Rezoning Request – The Central District (Extension) Outline Zoning Plan No. S/H24/6

Proposals to Amend the Outline Zoning Plan to Reduce the Amount of Reclamation, Reduce the Amount of Commercial Development and Reduce the Extent of Roads

Volume 1
Planning Statement

保護海港協會有限公司
Society For Protection Of The Harbour Ltd

FIGURE 8

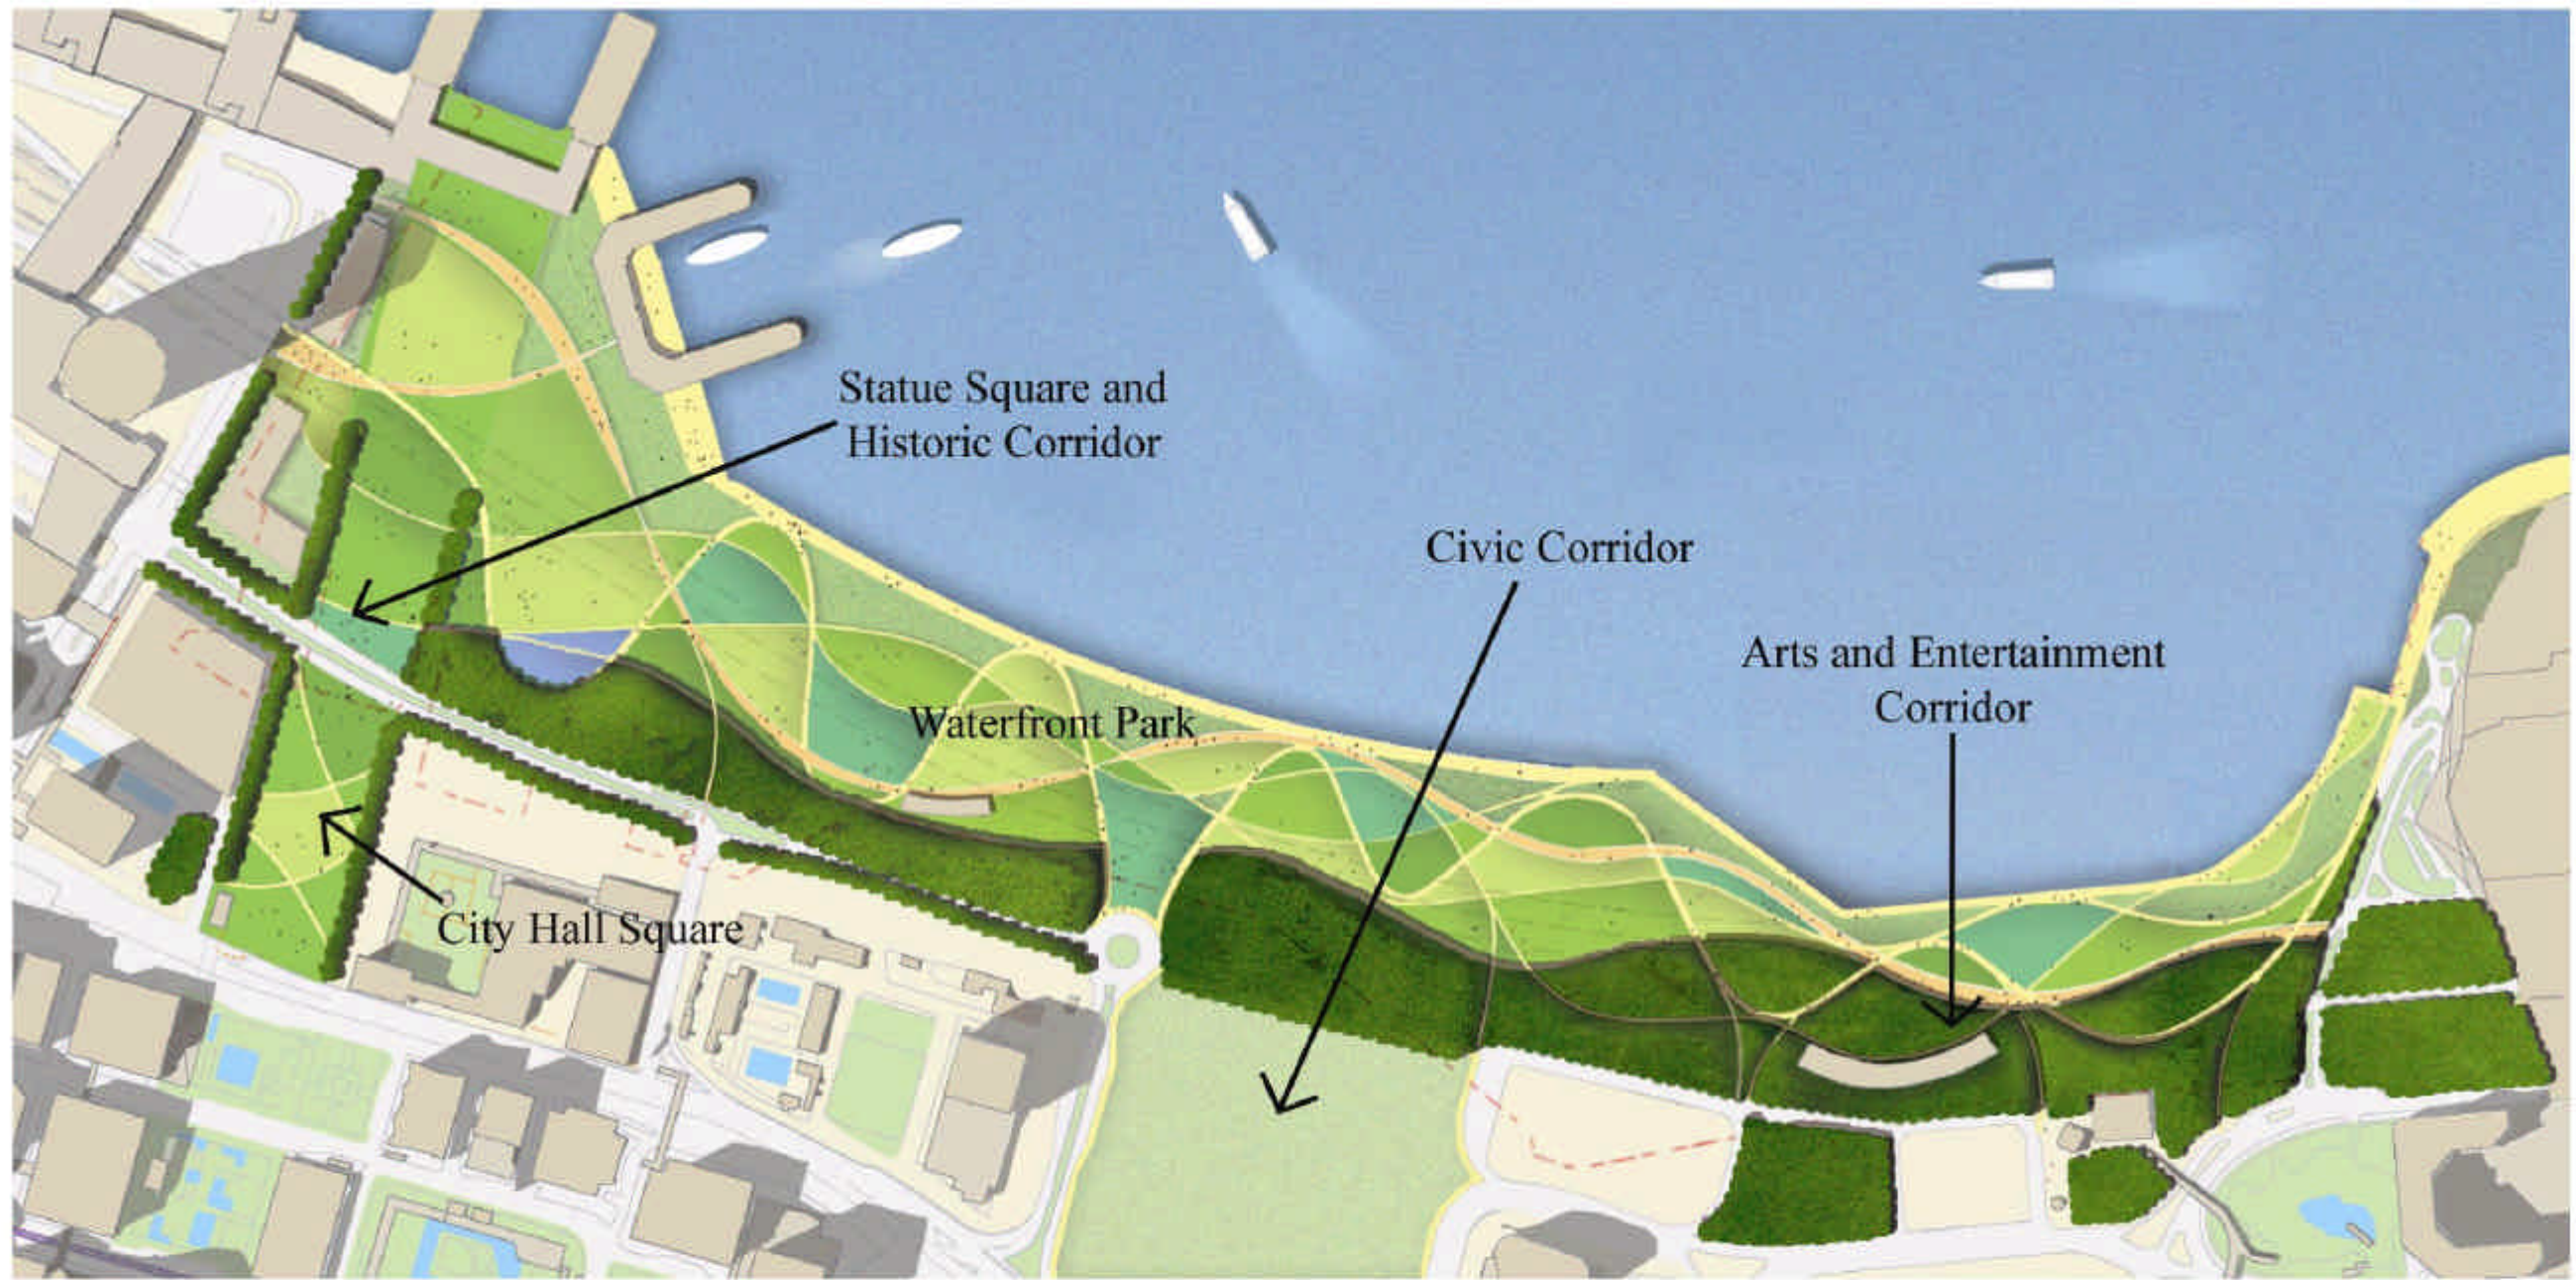
Government proposed Groundscraper extends over Connaught Road into Statue Square, obstructing views. The alternative proposal is to provide a continuous open space view corridor.

FIGURE 11

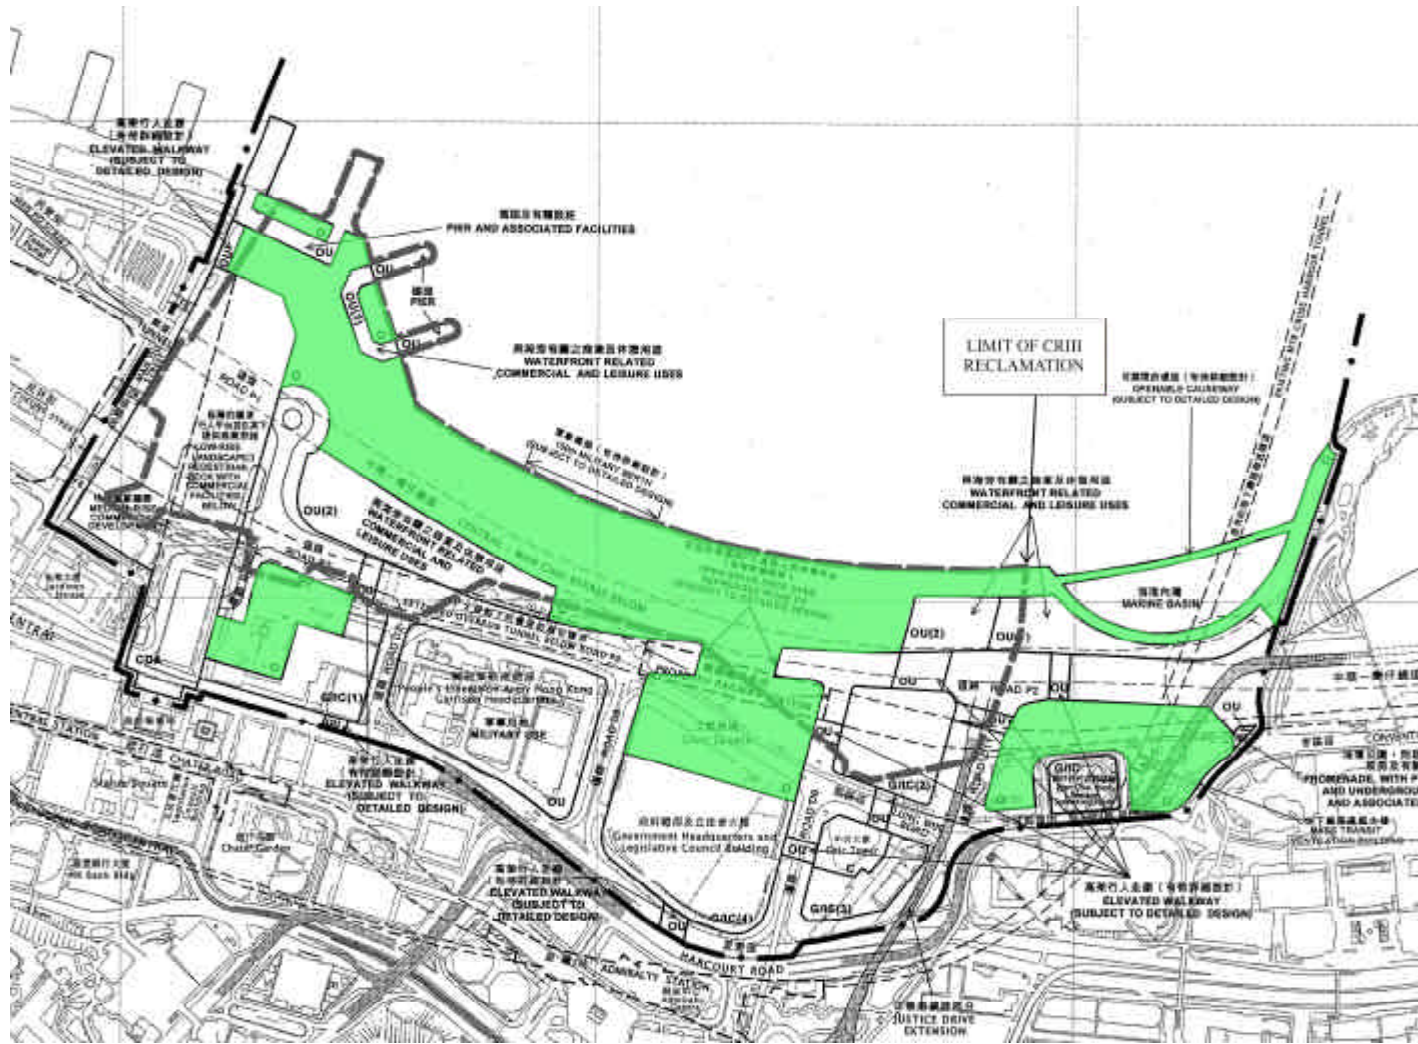
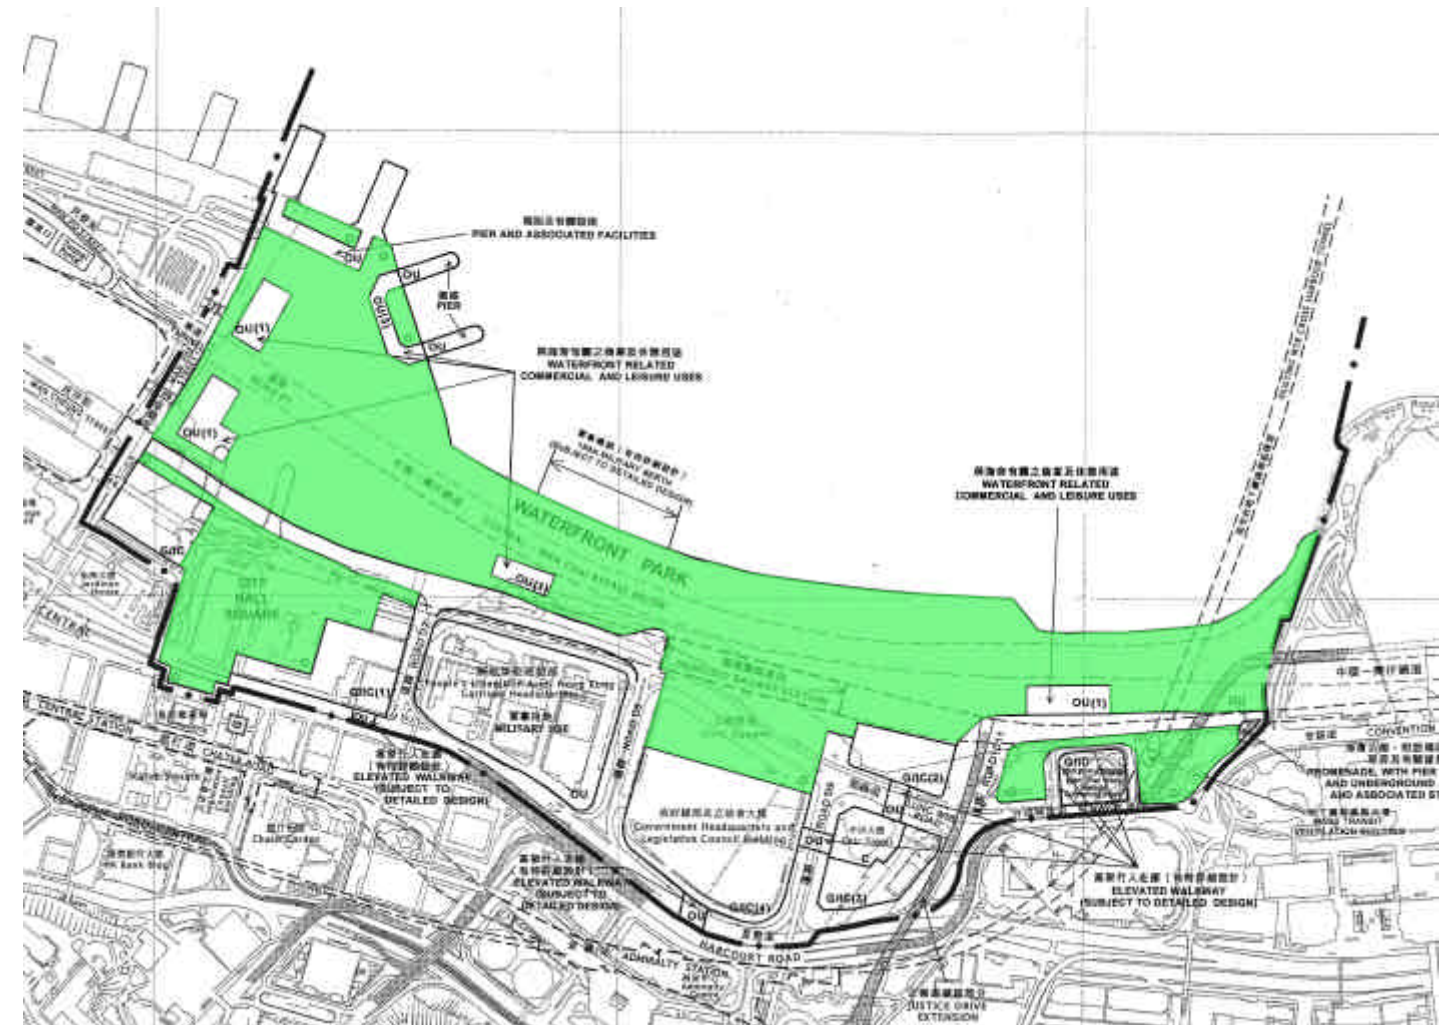
7.10 Table 1 provides a comparison of the various areas available for public use on the current Outline Zoning Plan and those on the rezoning proposal, and can be compared in Figure 11. While increase in site area is significant, this must also be considered in the context of the improved quality of the space and the improved accessibility for pedestrians. It provides tremendous scope for a magnificent waterfront.

FIGURE 12 Proposed Amendments to the Outline Zoning Plan

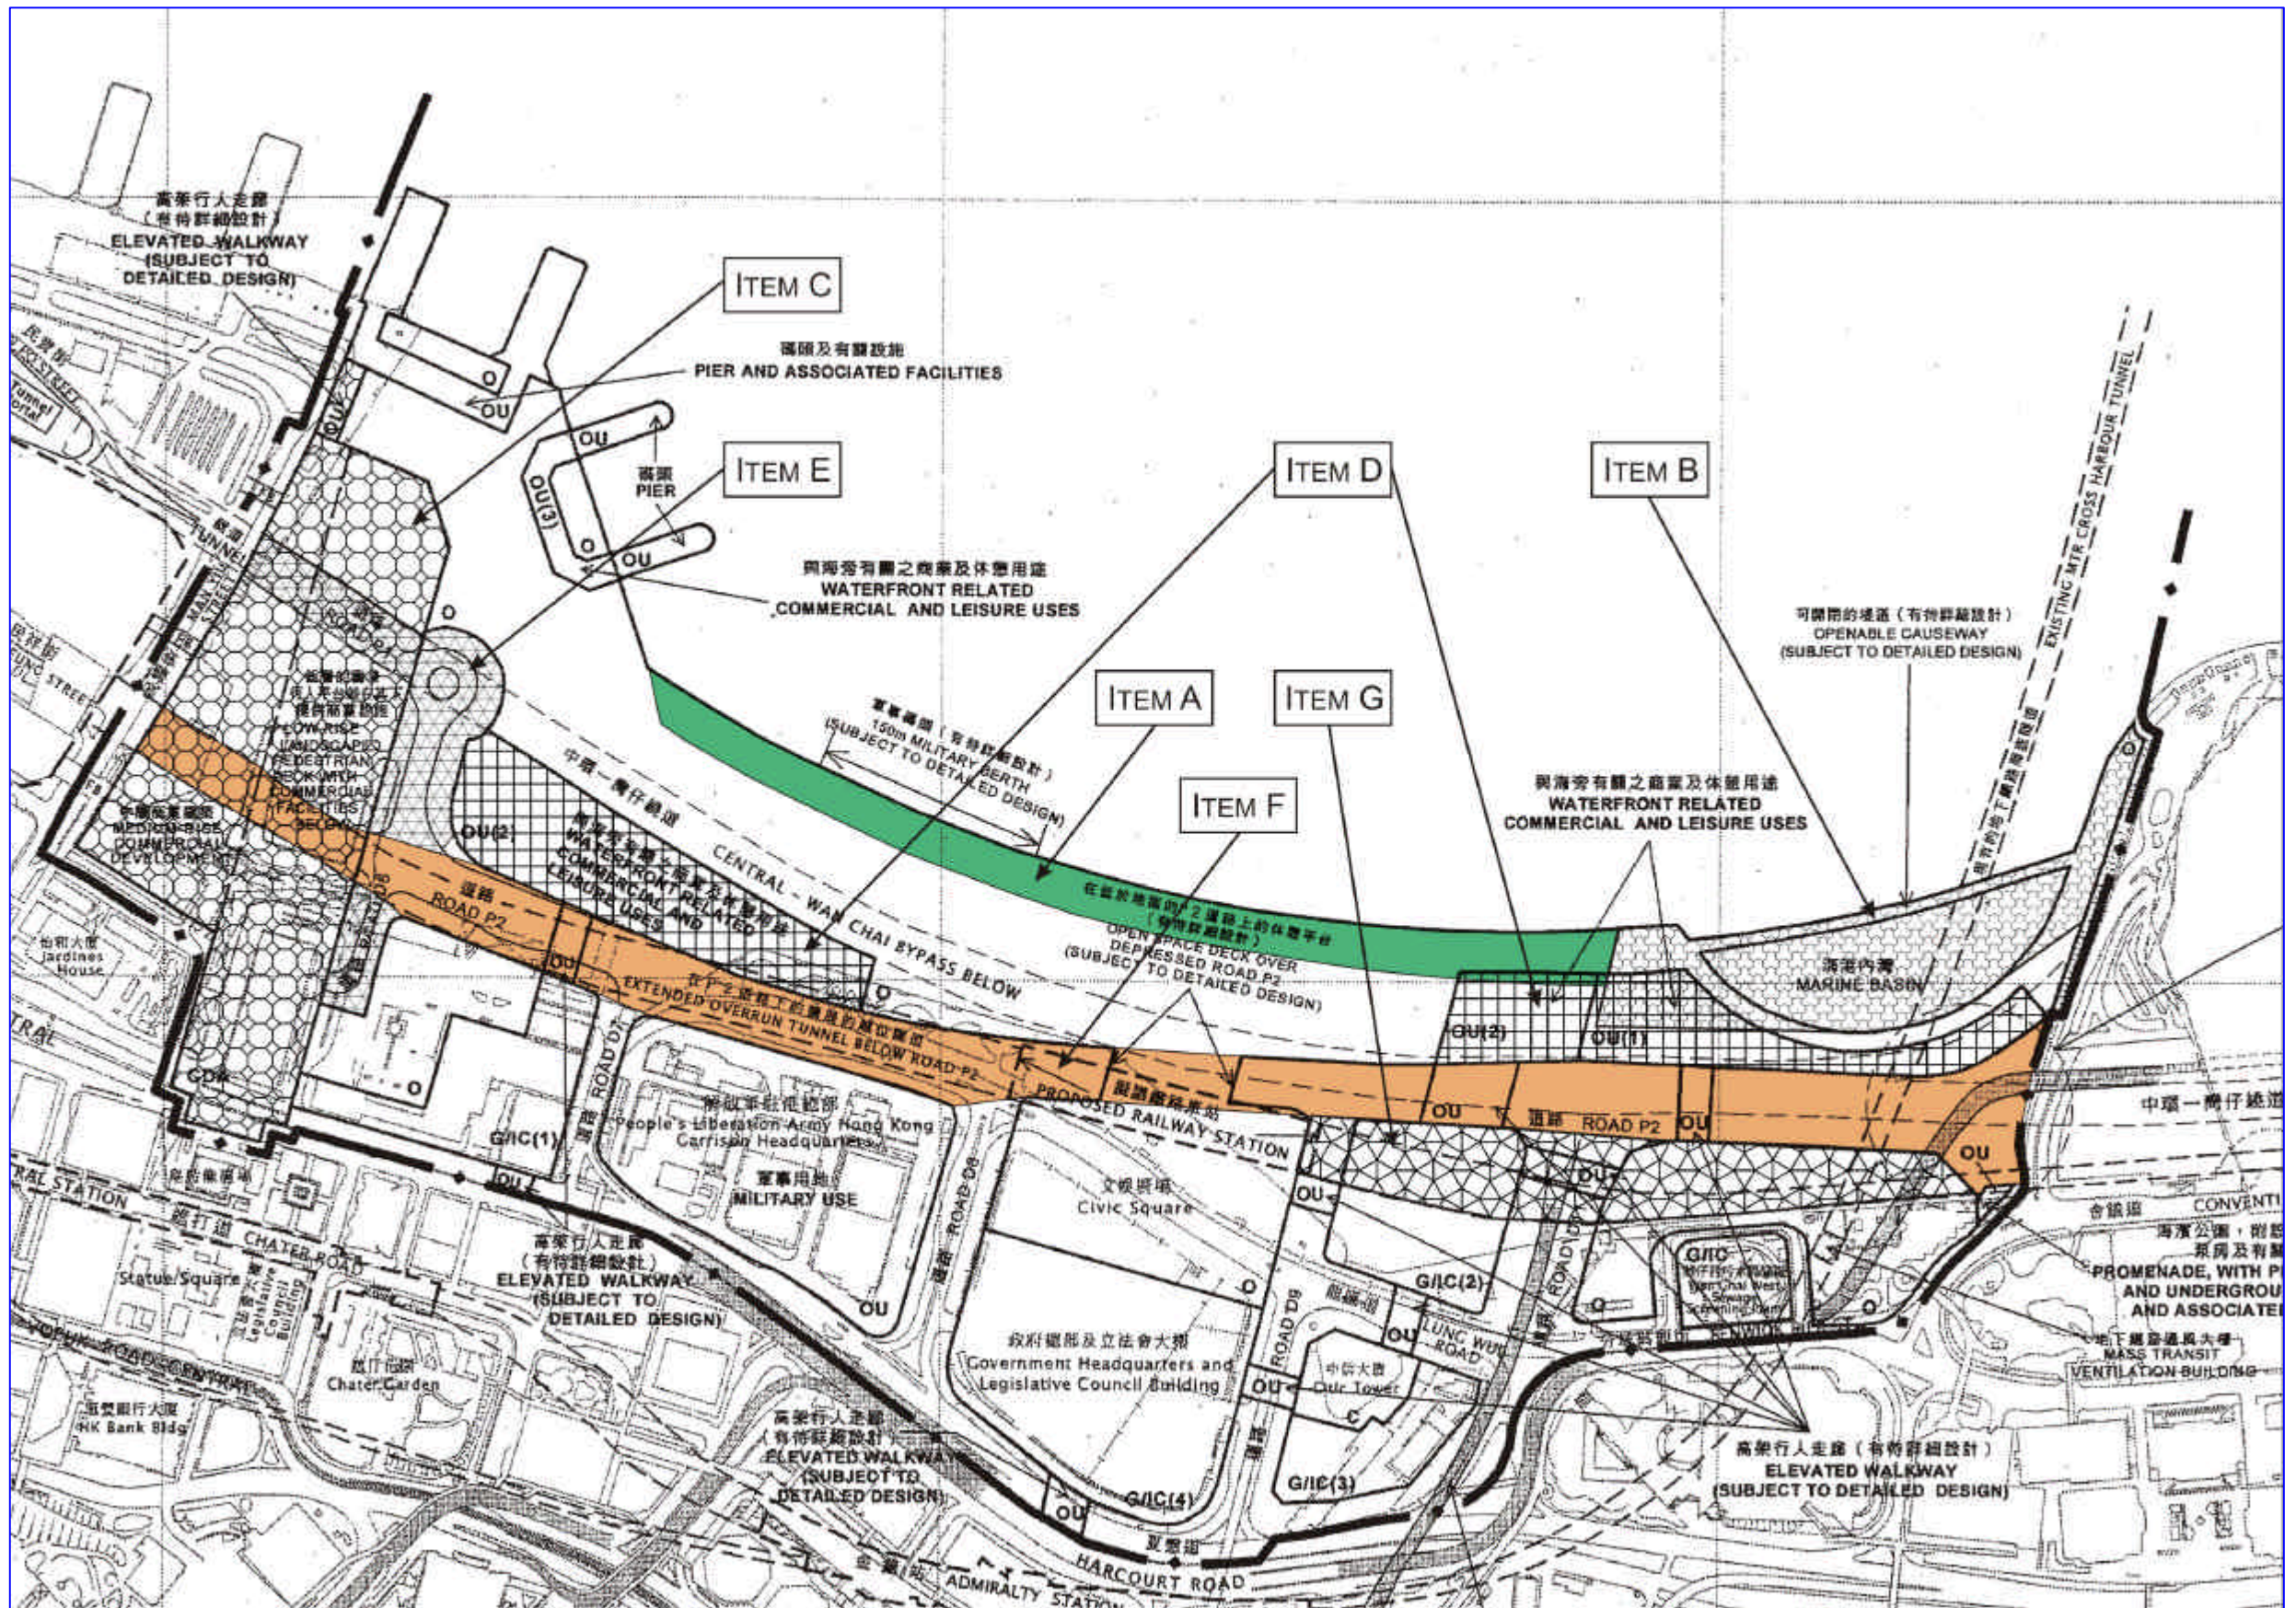
The technical submissions relating to the design of the sea wall and the alternative means for accommodating the air conditioning requirements of existing buildings clearly indicate that the amount of reclamation is excessive within the CRIII area as shown by Amendment Item A. In view of this conclusion, the CFA "Over-riding Public Need Test" cannot be met and the Board should amend the Plan so as to conform with the PHO. The actual reduction in the amount of reclamation could then be implemented through variations to the contract now in progress. This would result in a reduction in reclamation of approximately 2.4ha.

This indicates the area of excessive reclamation which is proposed outside the limits of the CRIII contract and is therefore not committed in any way. The Board must review the need for this reclamation and it is submitted that there is no over-riding public need for this portion of reclamation. To conform with the CFA decision this amount of reclamation must be deleted from the Outline Zoning Plan. As a consequence the extent of the Outline Zoning Plan should be reduced and areas zoned "O", "Marine Basin", "OU(1)" "Openable Causeway" and "OU(2)" deleted from the plan. This would result in a reduction of approximately 2.2ha of reclamation.

8.3.2 The zoning for the new reclamation portion of the CDA zone area is changed to predominantly "Open Space" so as to provide a public park of a significant size. Two sites are rezoned to "OU(Waterfront Commercial and Leisure Uses)", with a maximum plot ratio of 2 and a maximum building height of 2 storeys. This scale is reasonable so as to provide activity and life on the harbour front. A portion is rezoned to "road" to the north of City Hall Square.

8.4.1 The need for sites for buildings to provide a focus for activities and interest on the harbour-front is recognised as important. However, these need to be in scale with the use of the site by people, and should therefore be of 2 to 3 storeys in height. These buildings should only be for uses which complement the public use of the waterfront for such things as restaurants, recreational and tourist activities. Commercial office use should not be permitted, only offices ancillary to the main permitted uses.

With the deletion of Road P2, a larger area of open space can be created by reducing the size of the GIC(2) site, while part of the "O" zone near the Sewage Plant can be rezoned for an OU(2) site to provide for entertainment and commercial uses as part of the "Cultural Corridor".
